24/02085/OUT | Outline (Access only) - Demolition of existing residential, farm buildings & equestrian facilities, development of 99 dwellings with associated landscaping, cemetery expansion & associated infrastructure | Hubbles Farm Hastings Road Pembury Tunbridge Wells Kent TN2 4JP

I am writing on behalf of Pembury Parish Council (PPC) in response to the planning application noted above. We are very familiar with the site and have carefully considered the application.

Whilst we understand that the application relates to a site allocated for strategic development in the Submission Local Plan (SLP), **we wish to object to the proposal as currently submitted.**

Figure 1: Site allocation as per Submission Local Plan

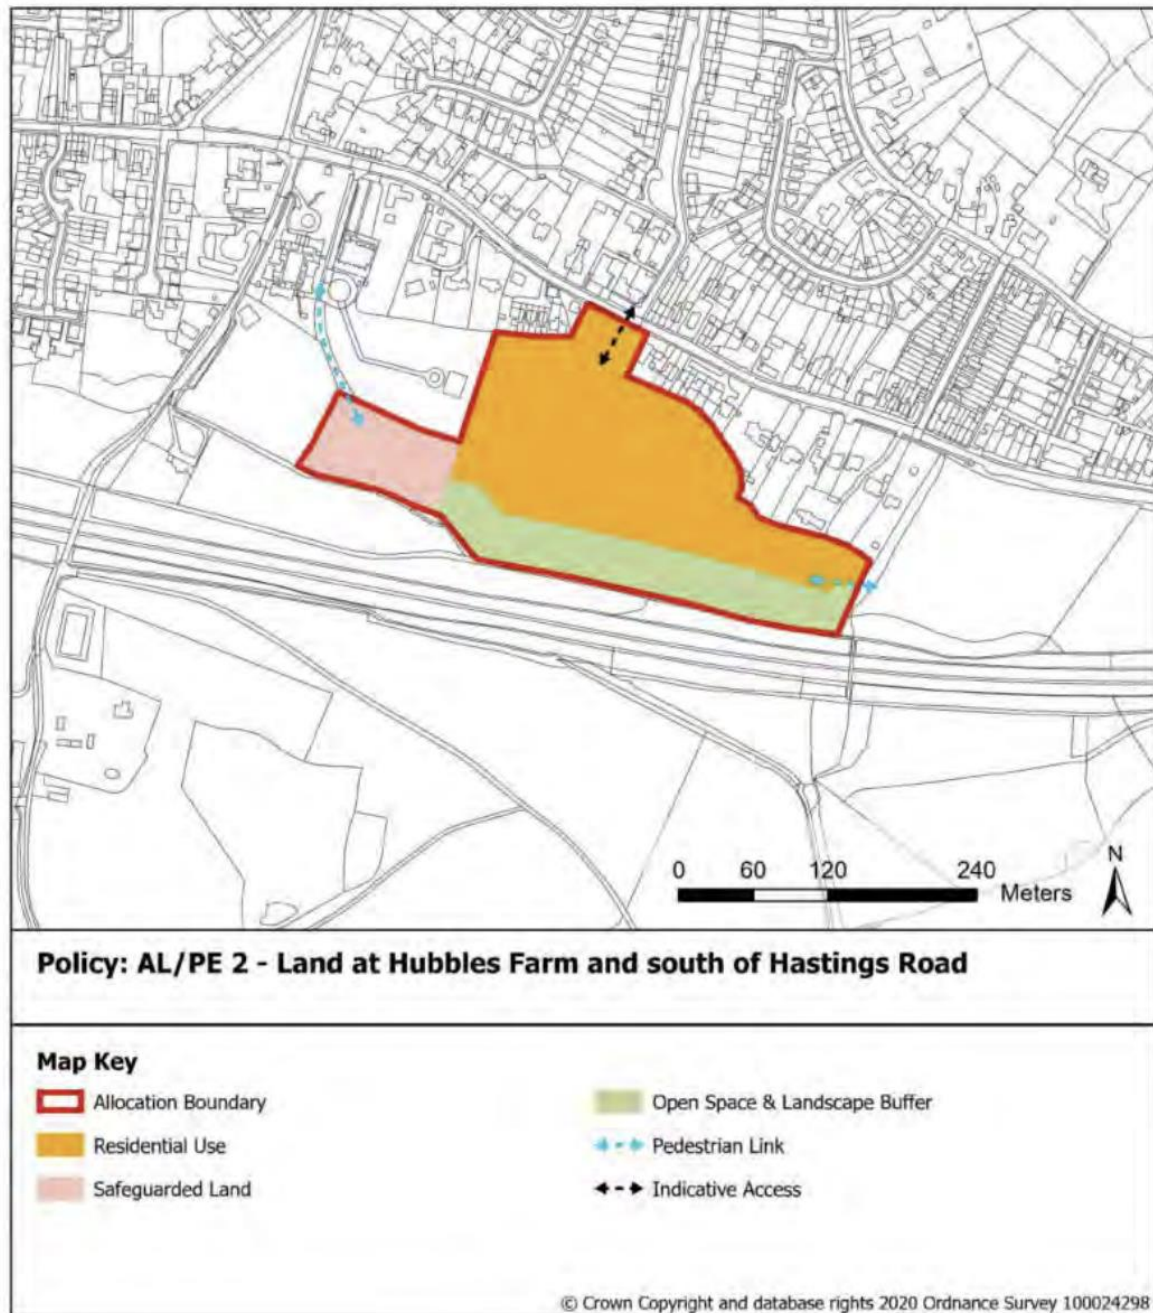
- 1.3. **Furthermore, when considered against the new Local Plan policies, it does not accord with the proposed site allocation in SLP Policy AL/PE2 in terms of the site boundary and associated uses across the site.** The map associated with Policy AL/PE2 (*Figure 1*) clearly shows the site allocated to include land at the west safeguarded for cemetery use (shown in pink). The area designated for residential use sits outside this safeguarded area (shown in orange). See also Clause 3 of Policy AL/PE2.

Figure 2: Limits to Built development in the 'made' PNP

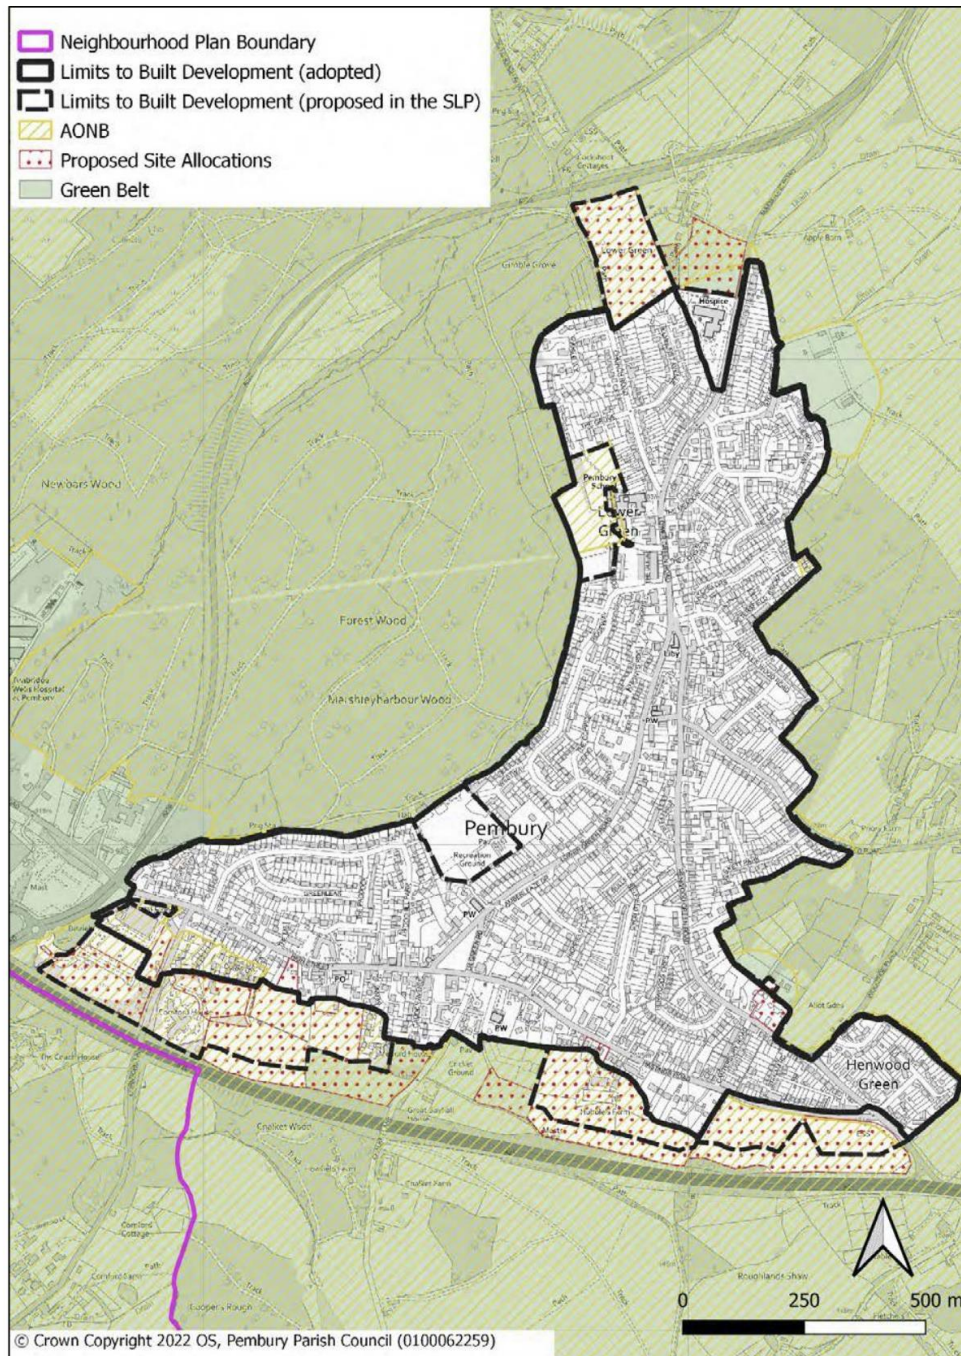
- 1.4. This is reflected in Policy P1 of the PNP, which forms part of the Development Plan and which shows both the existing (adopted) Limits to Built Development and those proposed once the SLP is adopted (Figure 2). The Figure clearly shows that the area of the proposed site allocation that is not proposed for residential use (i.e. the land safeguarded for cemetery use and the area to be a landscape buffer) do not and will not sit within the Limits to Built Development. Policy P1 of the PNP sets out the criteria against which any development in such areas must meet, which is not in line with the Application as currently presented.
